Modification Bulletin

Model: Adonis-C3 ARDF (DF76)	Date: 8-Jan-04	No.: MB541001
------------------------------	----------------	---------------

Model: Adonis-C3 ARDF (DF76) Date			e: 16-Sep-04		No.: MB541002		
Modified Article: Pressure Plate Assy				Prepared by: K. Takagi			
From: 1st Tech. Support Sec. Service Support Dept.							
Reason for	Parts catalog correction	☐ Vendor change☐ To improve rel		ange	☐ To m	neet standards	
Modification:	☐ To facilitate assembly			e reliability	()	
	□ Part standardization	Other

Installing the Velcro Patches ("Cushion" and "Cushion Tape")

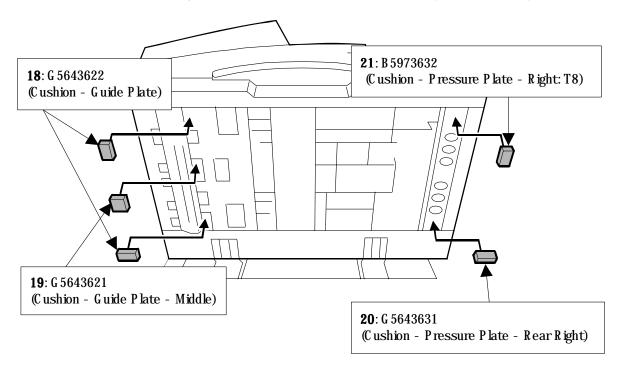
Old part	New part	Description	Q'ty	Int	Page	Index	Note
number	number						
B3514351	B5974311	Pressure Plate Assy	1	X/O	21	10	
B3514333	-	Cushion - Pressure Plate	2-0		21	15	
B3514322	B3514322	Tape - Platen Sheet	4-1		21	9	
	B5974326	Cushion Tape - Left	2		21	16	
	B5974333	Cushion Tape - Middle	2		21	17	
	G5643622	Cushion - Guide Plate	2		21	18	
	G5643621	Cushion - Guide Plate - Middle	1		21	19	
	G5643631	Cushion - Pressure Plate - Rear	1		21	20	
		Right					
	B5973632	Cushion - Pressure Plate - Right:	1		21	21	
		T8

Reason: Parts standardization with the Model - JC1 ARDF (DF77).

- 1. Remove the Pressure Plate.
- 2. Remove the 5 old Velcro patches from the underside of the ADF.
- 3. Attach the new Velcro patches to the underside of the ADF (#18-21 below).

4. Attach the new Velcro patches to the underside of the Pressure Plate (#9, 10, 16, 17 below):
